# Abnormal Chirp or Squeak Noise from High Pressure Fuel Pump

YEAR(S)	MODEL(S)	ADDITIONAL INFORMATION
2013 – 2014	FR-S

### REVISION NOTICE

Figure 1.

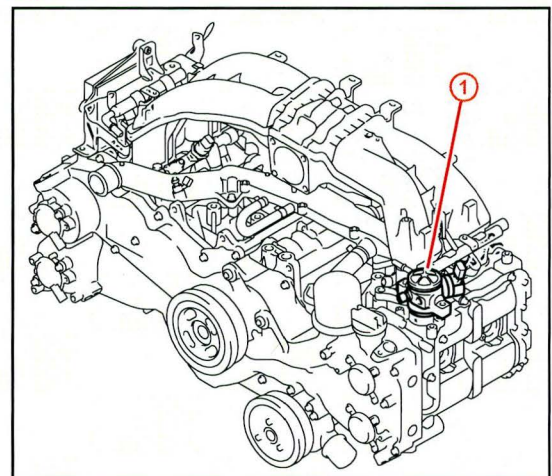
1. Road test the vehicle for at least 10 minutes so that the engine is fully warmed up.
2. While the engine is idling, listen for abnormal noise from the High Pressure Fuel Pump Assembly.

#### NOTE

- A mechanical ticking noise from the High Pressure Fuel Pump Assembly is normal during Direct Injection system operation.
- This bulletin should only be performed if an abnormal high pitch chirp or squeak noise from the High Pressure Fuel Pump is verified.

- **YES** — Continue to step 4.
  - **NO** — This bulletin does NOT apply. Continue diagnosis using the applicable Repair Manual.
4. Replace the High Pressure Fuel Pump Assembly.
